Re: **Response to TCL Comments Dated 12-30-2020 (K16d022A)**
The Strider
Address: 109 Vassar Drive SE

This letter serves to address your review comments of the Traffic Circulation Layout (TCL) submitted for The Strider project. As a continually developing project, minor revisions have been made to the site plan to coordinate with updates to the building design. However, the primary intent of the site plan remains unchanged from the original submittal.

1 Typical Driveway Detail

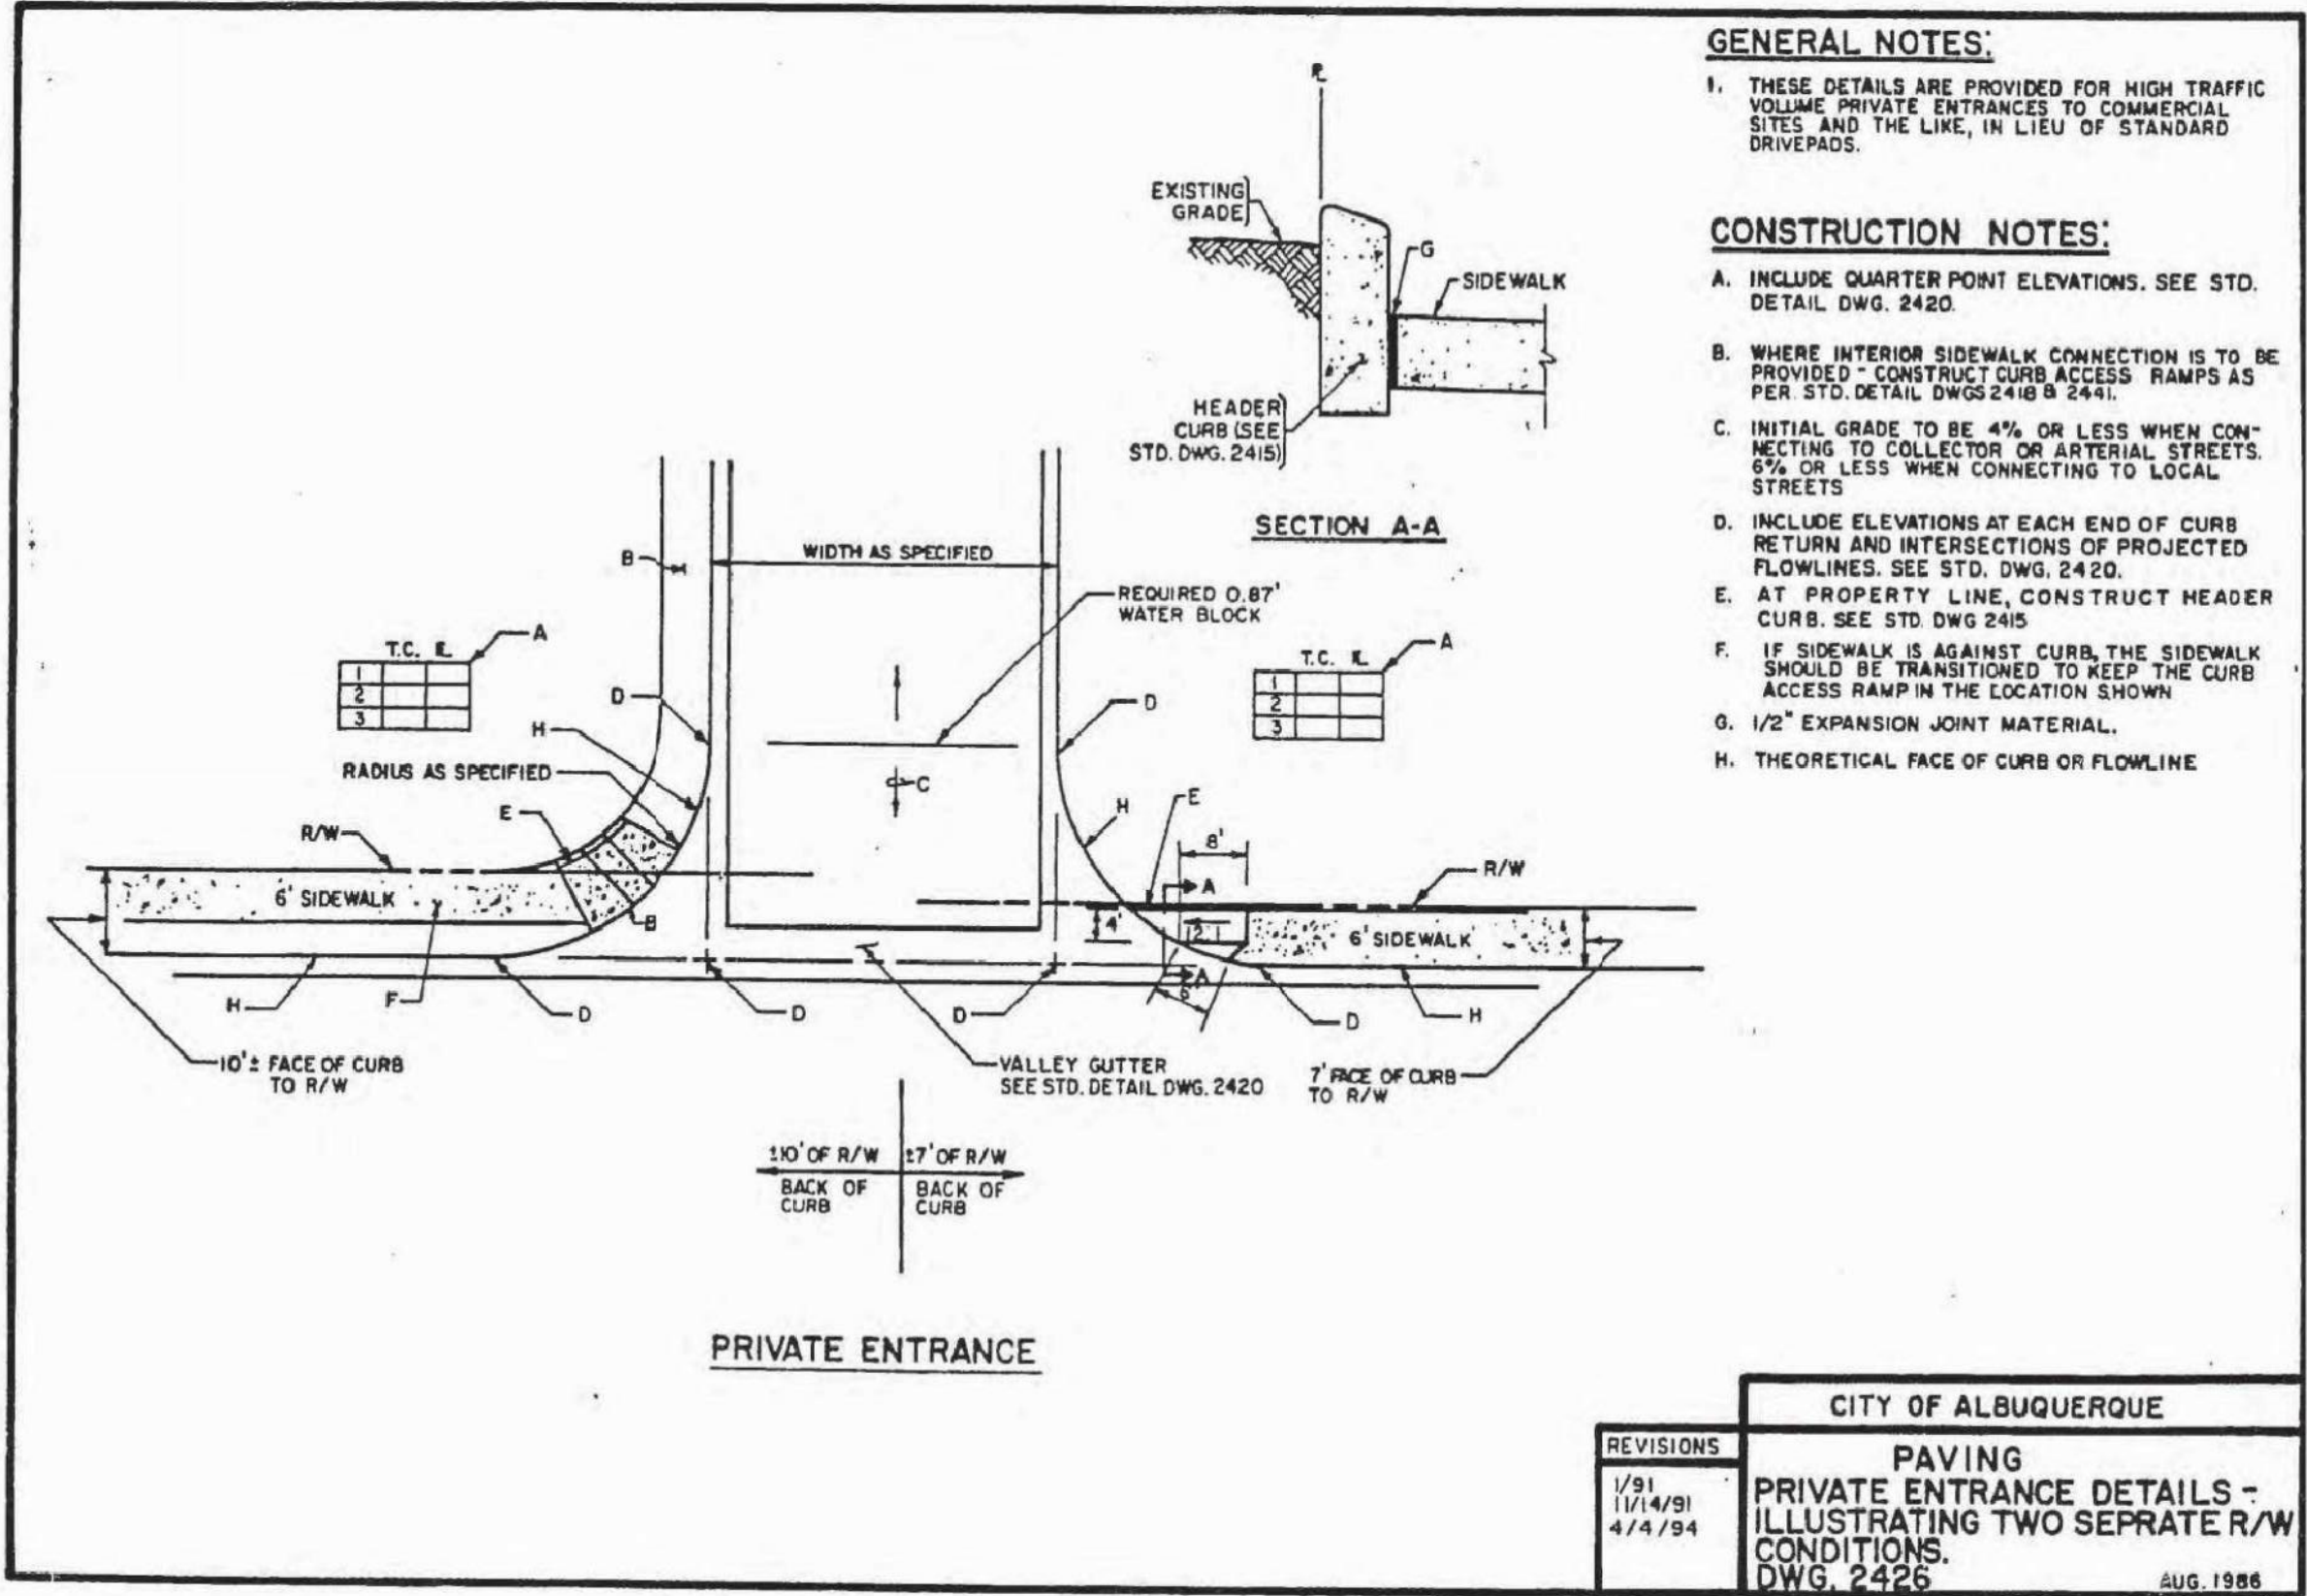
- 5) Access driveways: Both new access driveways are now noted on the TCL site plan, with the associated COA standard detail number. Additionally, a typical access driveway detail has been added to the typical site details sheet TCL003.

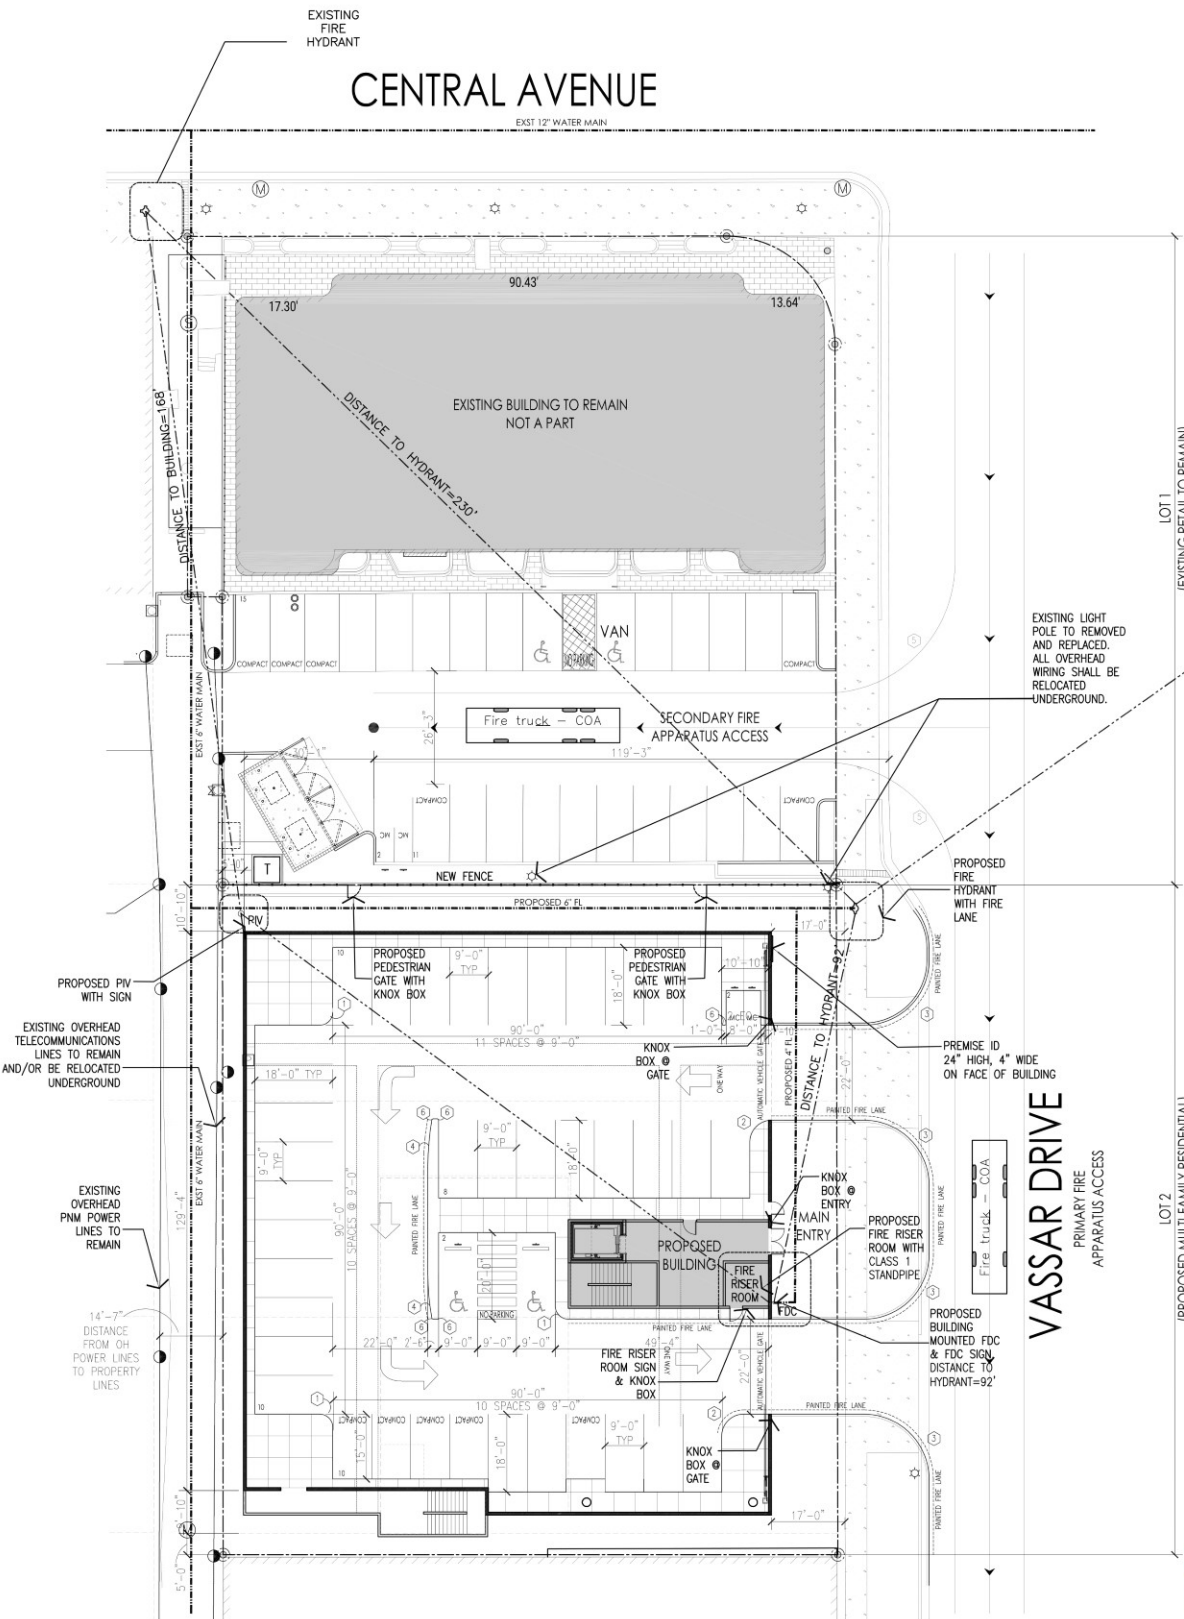
- 6) Fire Marshal's Office Approval: Please refer to the attached approved FIRE001 Fire Safety Site Plan. As a continually developing project, the site plan underlay deviates slightly from the submitted TCL documents. However, the primary intent of approved fire access components remains unchanged.
